B. GE Technical Exhibit 5 (Analysis and Recommendations Regarding Mass Effluent Limits for Outfalls 001, 005 and 009)

I. MASS EFFLUENT LIMITATIONS IN DRAFT PERMIT AS COMPARED TO THOSE IN CURRENT PERMIT

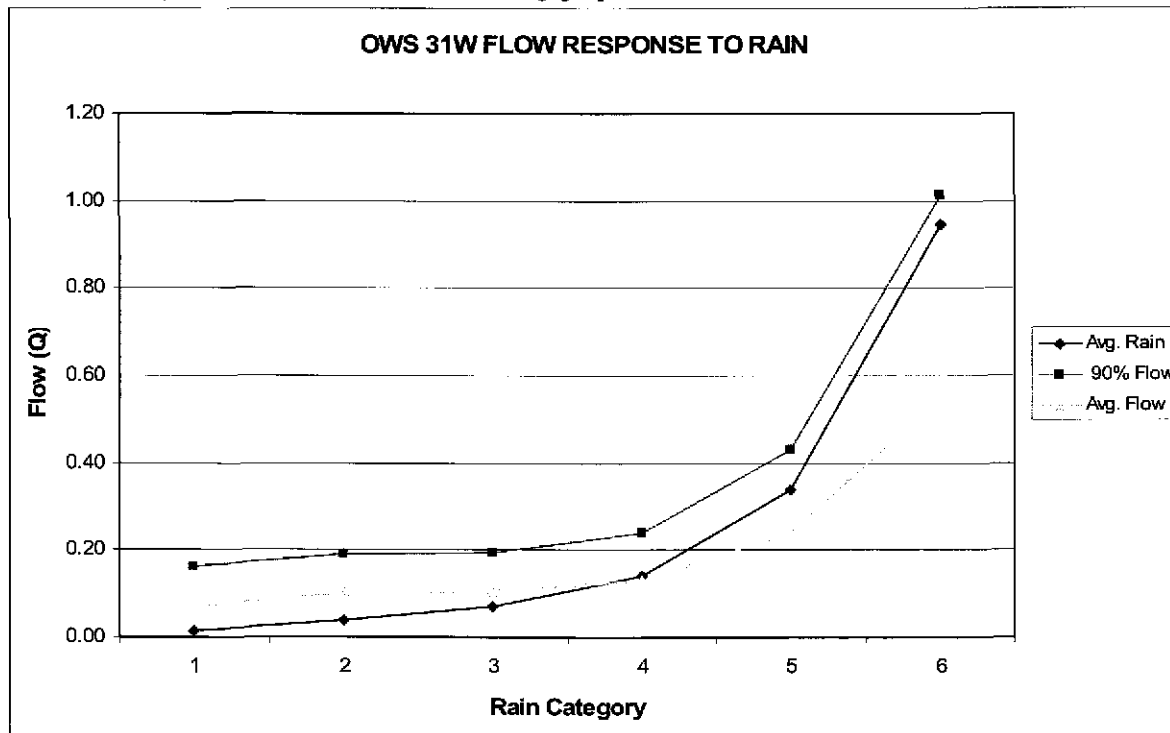
OWS 31W, which treats waters going to Outfall 001, poses unique challenges with regard to reduction of TSS. Unlike the other OWSs at the site, 31W receives municipal runoff from a large off-site drainage area (about 90 acres). The runoff from that area will contain a variety of solid materials that are not present on-site and which pose treatment difficulties for OWS 31W that are not presented for other site discharges.

Flow can be used as an indication of the potential ability for the 31W OWS to reduce influent TSS. Using Outfall 001 flow generated from 2002 to current, it is apparent that the OWS conditions during certain rain events are distinctly different from the representative OWS conditions assumed to have been the basis of the technology-based 138 lb/d. For instance, in response to rain events, there where will be a time period¹⁸ when flow through the system surges (increases), thereby reducing residence time for particle settling and causing turbulent flow through the OWS. One method to determine the average 24-hour flow that is representative of the conditions applicable to the 138 lb/d, is to evaluate the relationship between flow and rain events. The focus of this evaluation is to determine when there is a statistically noticeable flow response of the OWS (over a 24-hour period) to rain events. To have a rugged database, a rain event is defined as the sum of all rain or snow melt for the 72 hours prior. As there is a difference between flow during periods of rain (average = 0.17 mgd) and no rain (0.089 mgd), the relationship between increments of rain and the flow corresponding to those increments was used to evaluate the response of the OWS to rain-influenced flow. The increments of rain summarized into rain categories are:

For specific categories of rain amounts, there is a response in average flow and 90th percentile flow when rain amounts are greater than 0.1 inch (Category 4). When rain exceeds 0.2 inches (Category 5), the 24-hr average 90th percentile flow is statistically related (*i.e.*, similar line slope) to the average rainfall. In addition, the average flow line slope also noticeably changes above Category 5. Therefore, the conclusion can be drawn that the flow through the OWS distinctly changes in response to rain events more than 0.2 inches. The 90th percentile flow for rain events greater than 0.20 inches is 0.432 mgd. The implication of this analysis is that the OWS, for a 24-hour period, will be operating in conditions distinctly different than conditions assumed to be applicable for the TSS mass limit of 138 lb/d (*i.e.*, ability to settle particles, lack of turbulent flow).

The maximum flow in the historic DMR TSS database, when rain occurred (either 72-hr or 24-hr prior to the end of the 24-hr composite period), is 0.554 mgd with a mass result of 221.7 lb/d. This TSS mass result is greater than the proposed monthly average TSS limit of 138 lb/d. The next highest recorded flow, when rain occurred, is 0.226 mgd with a TSS mass result that is below the proposed monthly average TSS mass limit of 138 lb/d.

The results of the analysis presented above suggests that flow conditions within OWS 31W undergo a significant increase due to rain events above 0.2 inches and the 90th percentile flow rate is about 0.432 mgd. At a flow rate of up to approximately 0.432 mgd, there appears to be a relatively consistent flow through the OWS, suggesting a relatively steady-state performance of the OWS. As discussed above, one of the primary factors influencing the effectiveness of the OWS in solids removal is the retention time within the OWS, which in turn is a function of the influent flow rate. So, at a constant flow rate, the performance of the separator will also remain constant. However, as the rainfall/snowmelt-induced flow through the OWS approaches and exceeds approximately 0.432 mgd, the conditions within the separator are much more dynamic, resulting in conditions that would likely reduce its effectiveness in solids removal (relative to the conditions present within the OWS at lower flow rates).

When the 24-hour average flow is above 0.432 million gallons in response to rain events, the performance of OWS 31W may not be representative of the conditions that were used to determine the monthly average mass limit of 138 lb/d TSS. Therefore, for determining compliance with the monthly average 'wet weather' TSS limit, data collected over a 24-hour period should be used if the 24-hour flow is less than or equal to 0.432 million gallons.¹⁹ When the 24-hour flow is greater than 0.432 million gallons, the data and mass result should be reported but not used for compliance assessment.

Finally, as to the specific information relating the measured flow through outfall 001 as a function of rainfall, GE has shown that as rainfall increases, flow through 001 also increases. This is not surprising, although the rate of increase shown on GE's diagram is exacerbated due to the way GE grouped storms and presented the data. The grouping of storms into "categories" rather than simply presenting the rainfall amounts resulted in a shortening of the scale on the x axis and a showed a more dramatic rate of increase than actually occurs. A presentation of the average rainfall per category versus the average flow per category (scaled off GE's graph, since EPA did not have all of the raw rainfall data) shows the increase to be fairly linear. The fact that the rate of flow increase increases is quite small for very small storms is also not surprising, given that small storms generate little runoff because of depression storage (puddles and storage in pore spaces), infiltration in pervious areas, and evaporation.

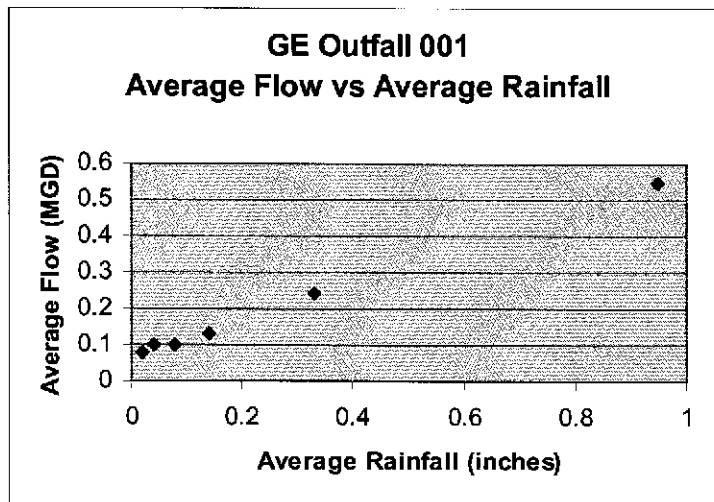
The commenter's assertion that differences in monitoring requirements between the 1992 and current permit alter the applicability of the numeric mass limitations reflects a misunderstanding of the sampling requirements in the 1992 permit. Under the 1992 permit, the permittee was required to achieve the effluent limitations under *all* weather conditions. While that permit did
